RMZX501 ZX5 Remove Chain and Sprocket Hazard

Replace infeed flights

Original Flight	Replacement flight
-----------------	--------------------

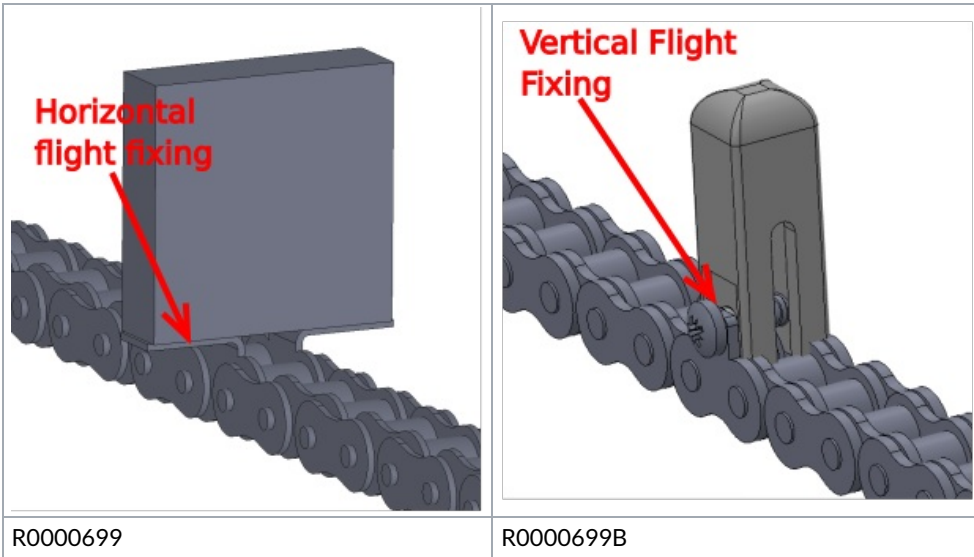
Hazard	Picture	LO	DPH	FE	NP	PHR	Rating
Finger trap infeed flight to front cover plate, when chain system is in reverse		Unlikely	Break Minor Bone	Daily	16-50	60	High
Finger trap infeed flight to front cover plate Infeed Light curtain not fitted		Unlikely	Break Minor Bone	Daily	16-50	60	High
Finger trap infeed flight to front cover plate Infeed Light curtain fitted		Impossible	Break Minor Bone	Daily	16-50	0	Zero

- Replace infeed chains and flights to narrow the flight width and remove the sharp edges of the flight upstands, by rotating through 90 degrees to vertical orientation
- Replace 9 off chains, each with 17 off flights
- Estimated fitting Time - 4 hours

Hazard	LO	DPH	FE	NP	PHR	Rating
Finger trap infeed flight to front infeed cover plate, chain reversing	Unlikely	Scratch or Bruise	Daily	16-50	1.5	Very Low

- Same HRN applies to entire infeed hazard when light beam is fitted
